A d d e n d u m

Iowa Department of Transportation
Office of Contracts

B.O.	Proposal ID	Proposal Work Type	County	Project Number	Addendum
101	18-0597-046	PCC OVERLAY - UNBONDED	CHEROKEE	NHSX-059-7(46)--3H-18	18MAR101.A02

'LJ-1' JOINT

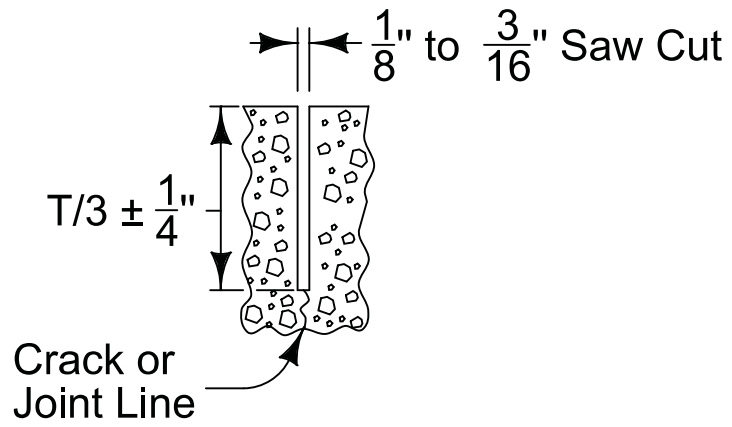
Typical EX-JNT A, replace longitudinal joints labeled 'C' Joint with 'L J - 1' Joint within the PCC Unbonded Overlay pavement.

Typical EX-JNT B, replace longitudinal joints labeled 'C' Joint with 'L J - 1' Joint within the PCC Unbonded Overlay pavement.

Insert Typical L J - 1, see attached PDF.
